STORMWATER MANAGEMENT FACILITIES OPERATION AND INSPECTION REPORT

NE1/4, Sec 34
0133.216
Name of Business/Subdivision
Address of Property
Ravenswood Subdivision

Dry Pond		Pond ID: SWP34n004	Location of Pond	Outlet 2 – Pond #1
Wet Pond	X			Southern Pond
Other

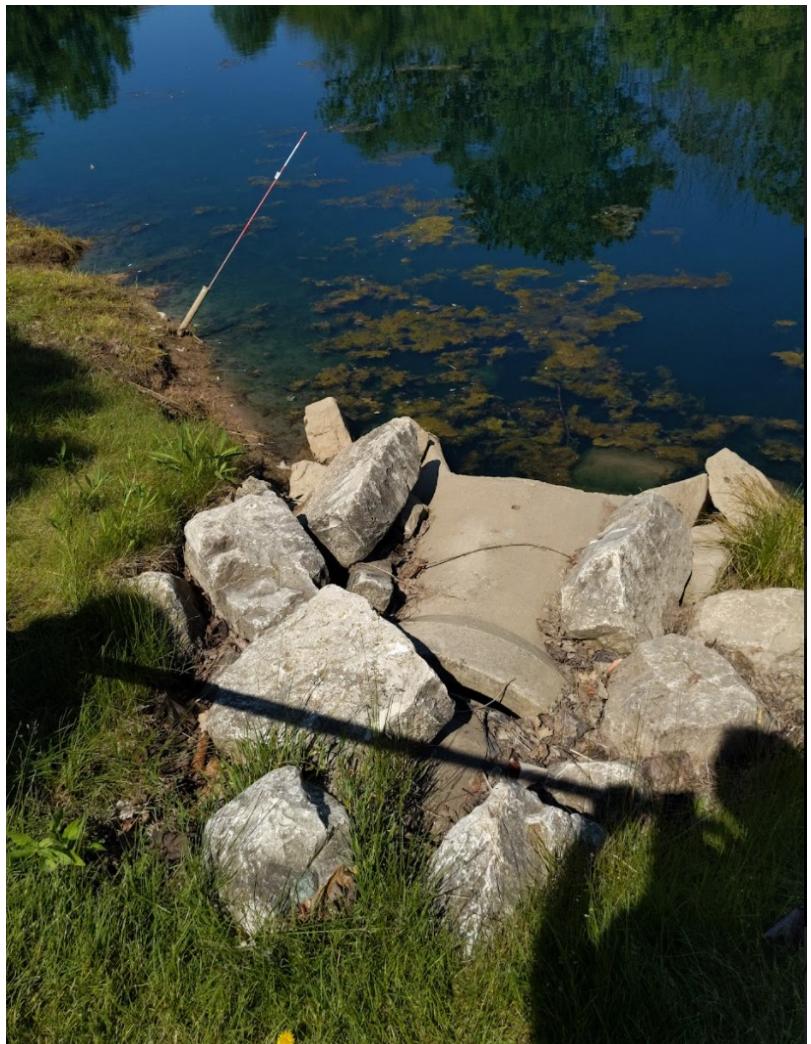
01/06/2021 10:23:34 AM
View of overall wet pond. Trees and woody vegetation shown here that should be removed.
